Cairn Gorm – the beginner’s ski slope planning application (1)

At the beginning of August Cairngorm Mountain (Scotland) Ltd, Highland and Islands Enterprise’s subsidiary which operates their business at Cairn Gorm, submitted a Planning Application to create a new beginner’s ski area ([see here for planning documents](#)). Parkswatch has covered this several times already ([see here](#)), ([here](#)) and ([here](#)) but the more you look at the application, the more issues it raises. In these posts therefore I have attempted to make an in depth review of the application and it’s supporting documents, highlighting mistakes and issues and raising some questions that need answered before a decision can be made.

Part 1. The Planning Application.

Planning map courtesy of CMSL planning application, supporting information page 4

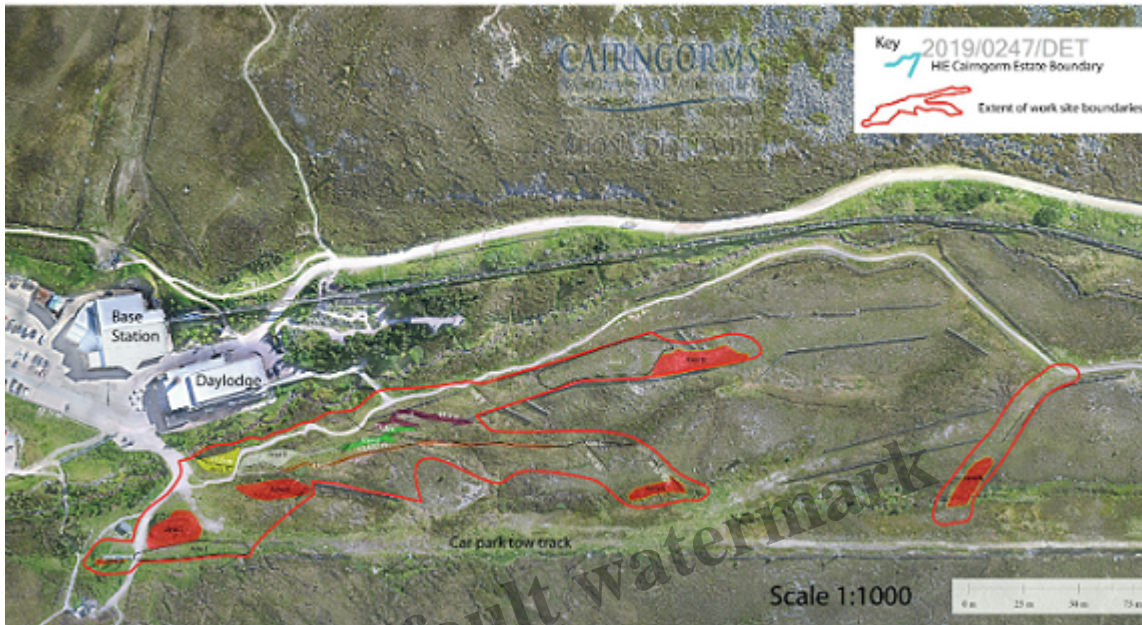
(1) The works site is described as being within the lower 300m of the slope. This is wrong as the access to Area N (see map above) is approximately 450m from the base of the Car park tow,

The site area, according to the application, is 0.93 hectares or 9,300 sq. m. There is no indication if this is the work area or the sum of the areas to be bulldozed! I have however worked out that it is the whole site, although by my calculations, which are approximate, the area is actually 11,388sq.m., while the area being bulldozed is over 2928sq.m.

Due to lack of clarity in the application documents, it is not possible to measure areas C & F. However, their total length is 187m. If we assume that a vehicle working on these areas creates a track 3m wide then the area of C + F is 561sq.m., bringing the total to 3489sq.m.
